Number	L.1
Section	Brakes
Sheet	1 (of 2)
Date	January, 1960

DISC BRAKE MASTER CYLINDER RECONDITIONING

Number	L.3
Section	Brakes
Sheet	1 (of 1)
Date	March, 1960

FIG. 1.

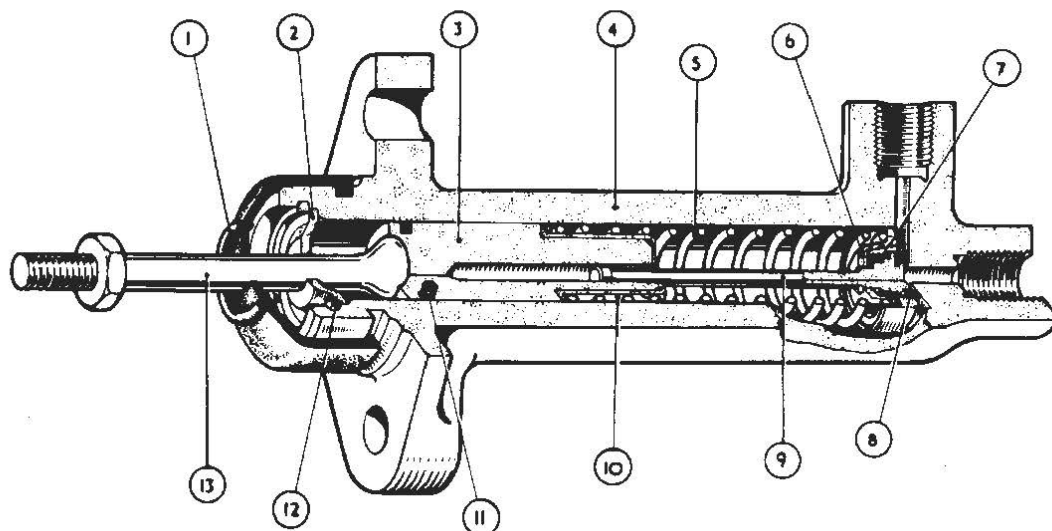
A new type of master cylinder is now fitted to cars with disc brakes and the assembly of internal parts, supplied as a reconditioning kit (Part number 8250), can be incorporated in the existing body of earlier type master cylinders when reconditioning master cylinders of that type. Individual parts are not supplied separately.

When reconditioning a brake master cylinder of the type shown in Fig.1. attached, the following procedure should be adopted.

- (1) Remove the dust excluder from the head of the master cylinder.
- (2) Remove the circlip (using circlip type pliers if available, alternatively, round nose pliers may be used). This will release the push rod complete with dished washer.
- (3) Withdraw the piston and valve assembly complete with springs and supports.
- (4) Discard the piston and valve assembly (items 3, 5, 6, 7, 8, 9, 10 and 11 on Fig.1) and the circlip (12).

FIG. 3

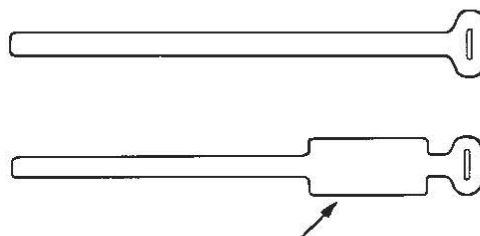
The identification tab fitted to these types of master cylinders and the tab included in the reconditioning kit 8250 have a widened portion as indicated by the arrow in Fig.3.

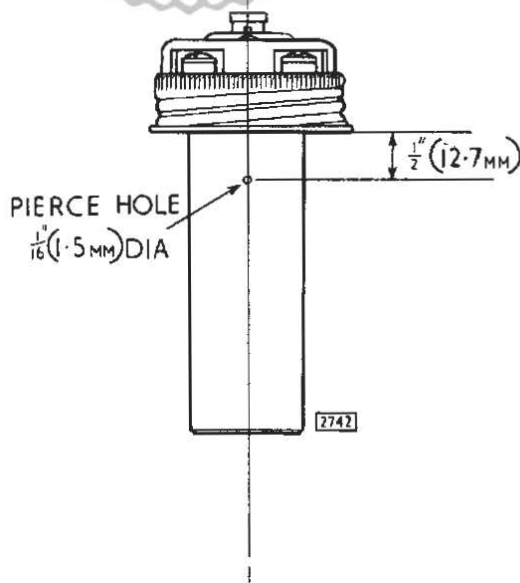
Isolated cases have come to our notice where the warning light has remained 'on' with the handbrake released and the brake fluid level correct.

This has been found to be due to a pressure difference between the inside and outside of the float container.

The remedy is to pierce (do NOT drill) a $\frac{1}{16}$ " (1.5mm) hole through the float container in the position shown in the illustration.

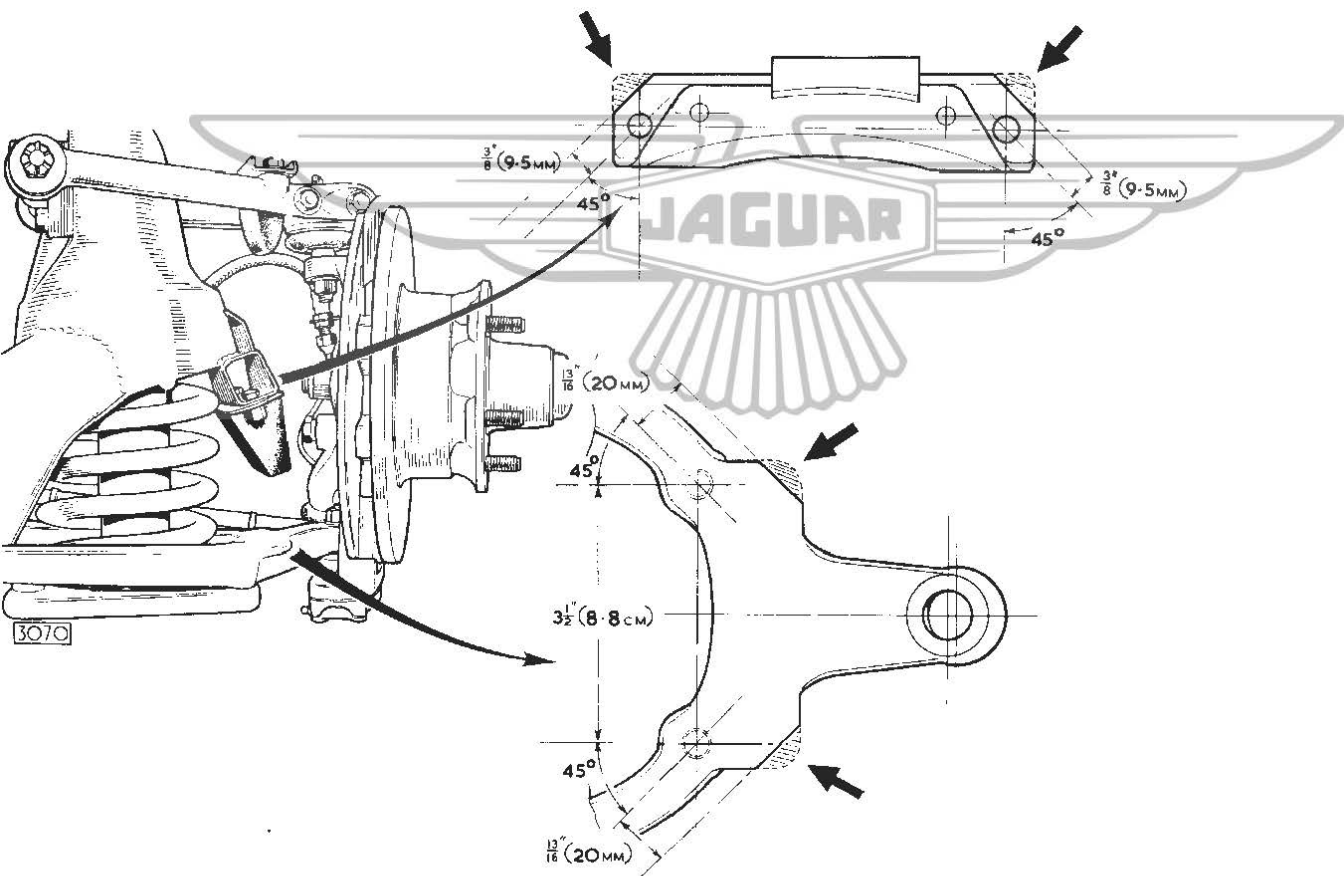
The new servo unit is of the diaphragm type in which there is no physical contact between the vacuum piston and cylinder. The vacuum piston push-rod is of a fixed length and there is no adjustment for clearance as there was on the 6 $\frac{7}{8}$ " servo.

In conjunction with this change the servo cowl, vacuum tank and hydraulic pipes are also modified.

MODIFICATION TO WHEEL ARCH.

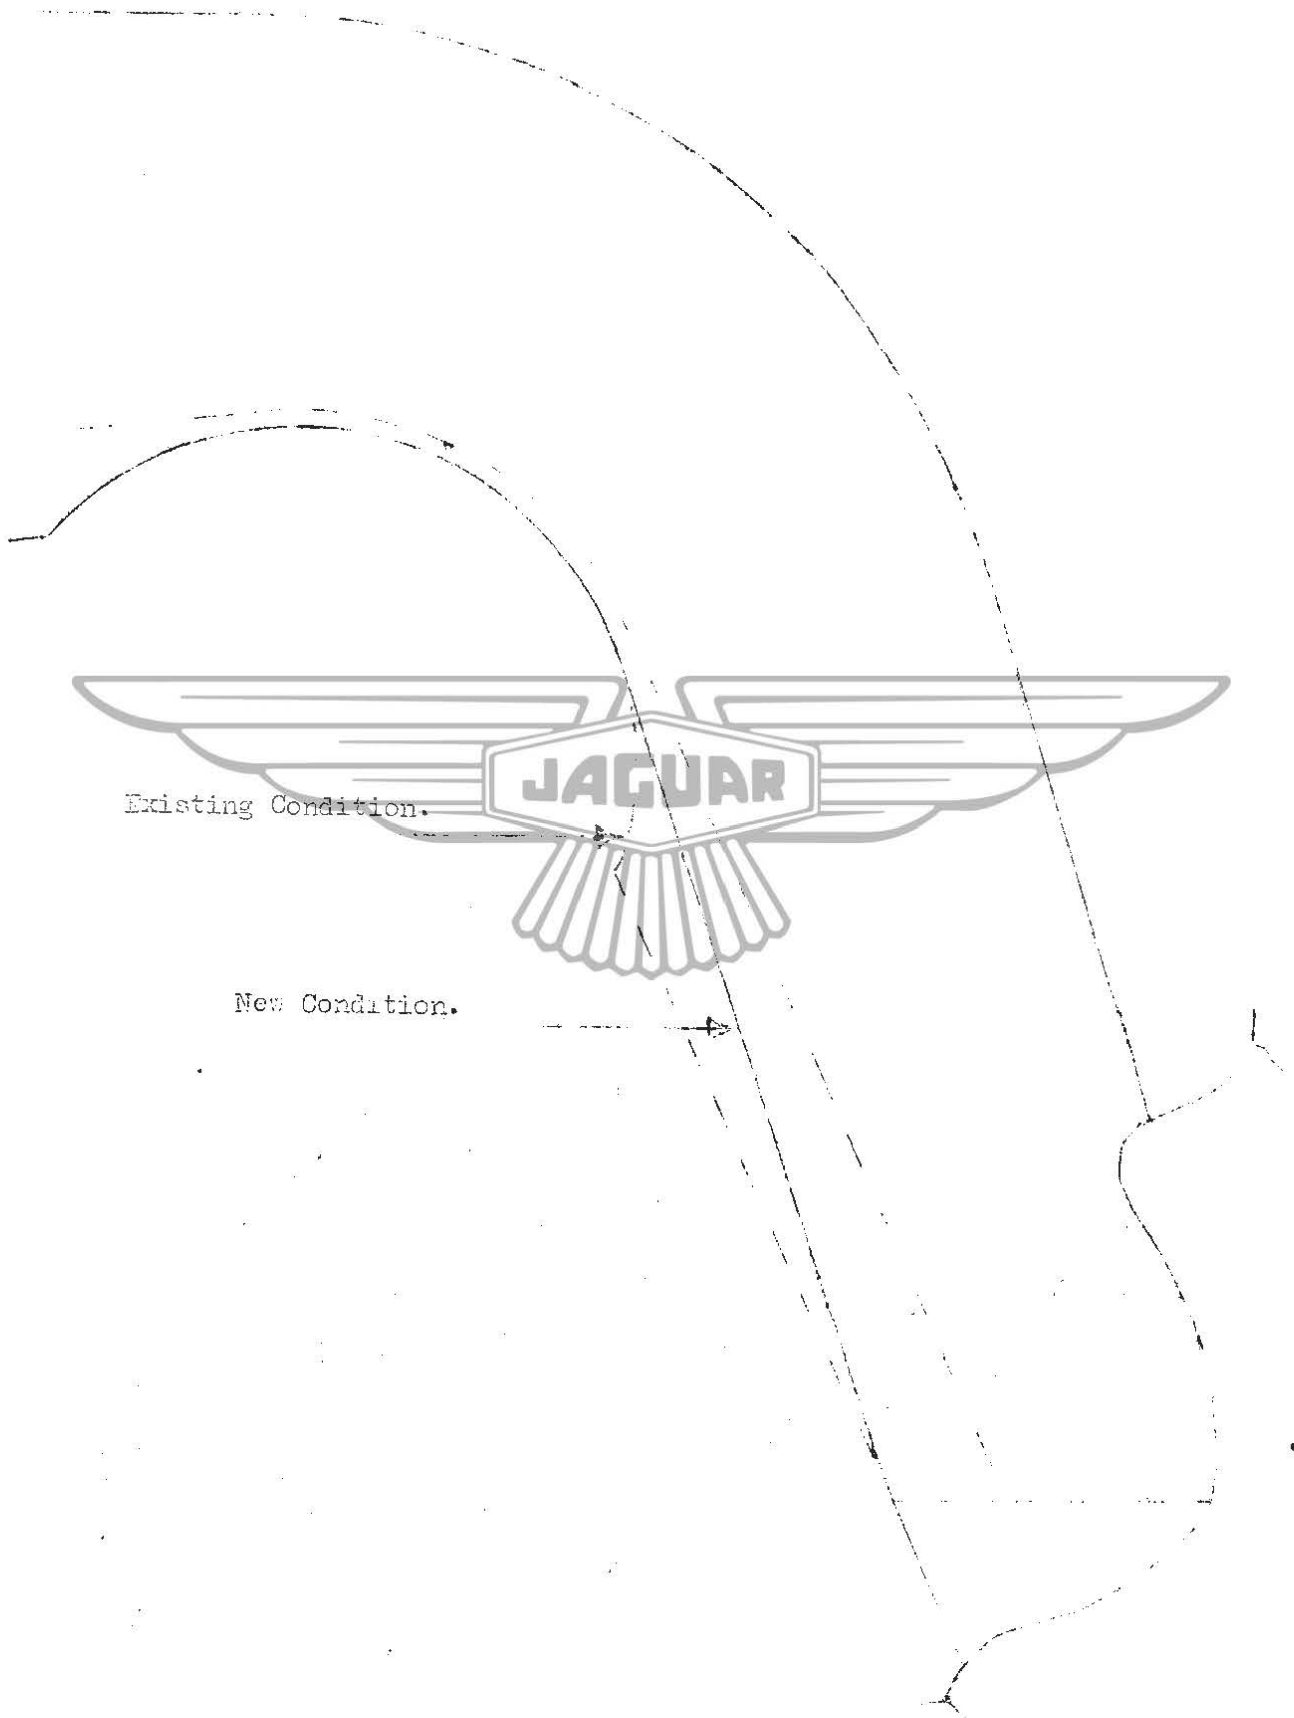
Note: It is IMPORTANT to carry out the above two body modifications otherwise fouling will take place between the handbrake compensator and trunk floor, and also between the handbrake cross cables and the wheel arches.

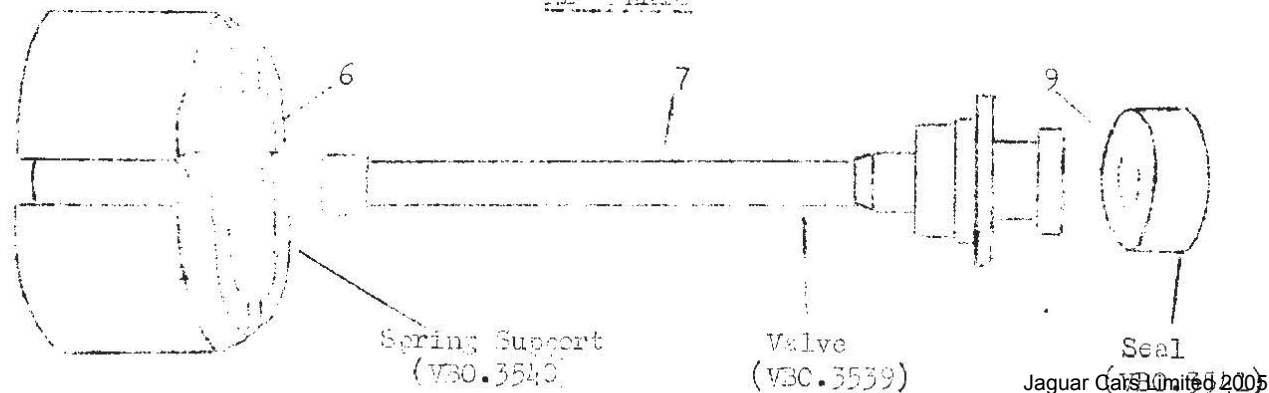
To deal with cases where a long brake pedal action is sometimes experienced on the first application of the brake pedal when the car has been standing, but normal pedal action is obtained on the second action of the pedal the following modification has been introduced in production commencing with chassis numbers:-

Note: A separate bush for the seal is no longer used. The drawings on the next page show the difference between the old and the new parts. The differences between the old and new parts are easily recognisable except in the case of the spring supports between which there is no visible difference. The old type spring support must not, in any instance, be refitted.

- (6) Using the new components (6), (7) and (9) shown in the sketch below reassemble items (4) to (9) inclusive in the order shown and retain them by engaging the valve (7) in the central bore of the spring support (5). NOTE: The old and new spring supports item (6) are almost identical in appearance but it is essential that only the new support is used for this modification.
